# Wisconsin Department of Transportation

**Proposal #4: 1111-03-70, WISC 2017 502**  
**Sun Prairie – Beaver Dam**  
**CTH VV – STH 73 & Various Bridges**  
**USH 151**  
**Dane, Columbia & Dodge County**

This is Addendum No. 01, which provides for the following:

**ADDENDUM NO. 01**

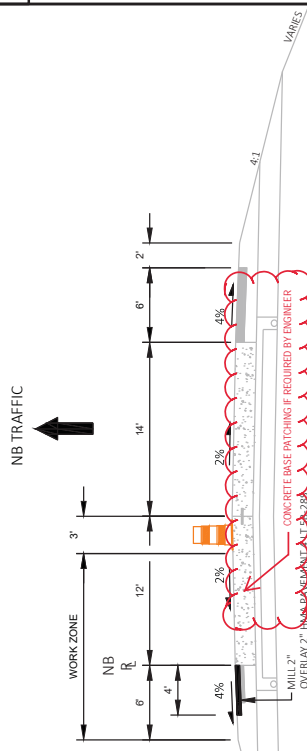
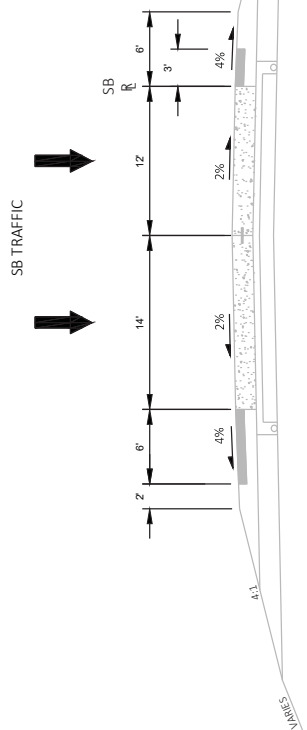
*Add the following to standard spec 390.3.2:*

Place each repair in one continuous, full-depth operation conforming to 415.3.6 and 415.3.7. Protect from cold weather as specified in 415.3.13.

**Addendum No. 01**  
**ID 1111-03-70**  
**Revised Sheet 56**  
**November 9, 2017**

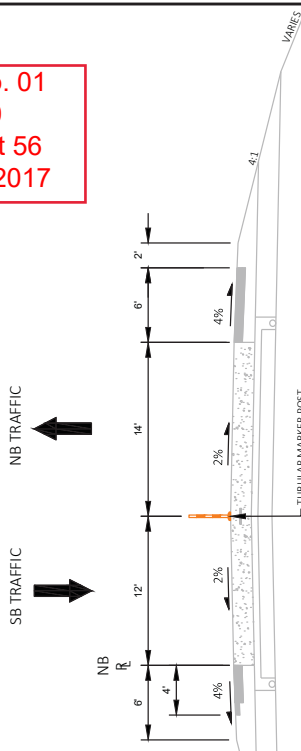
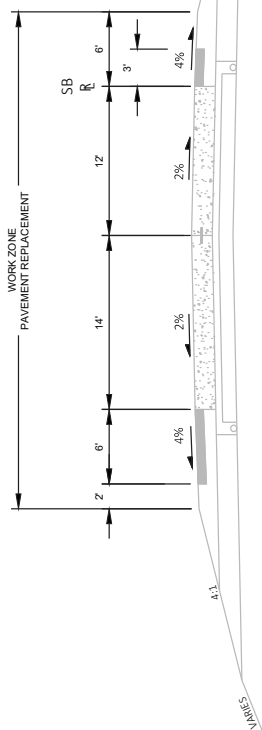
Revised Plan Sheets	
Plan Sheet	Plan Sheet Title (brief description of changes to sheet)
56	Construction Staging – Typicals (a note was added to the NB left lane to complete Concrete Base Patching if required by the engineer)
256	Structure B-11-75 Cross Section, Quantities & Notes (A note stating that “Alternatives to concrete deck patches may be used...” was removed from the General Notes)

Addendum No. 01  
 ID 1111-03-70  
 Revised Sheet 256  
 November 9, 2017

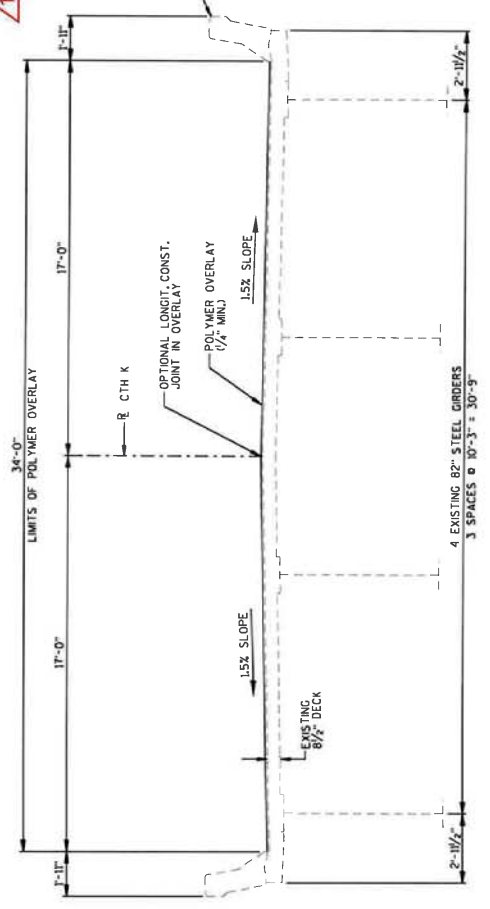
NO.	DATE	REVISION	BY
1	10/31/17	Removed Deck Patch Note	JRS
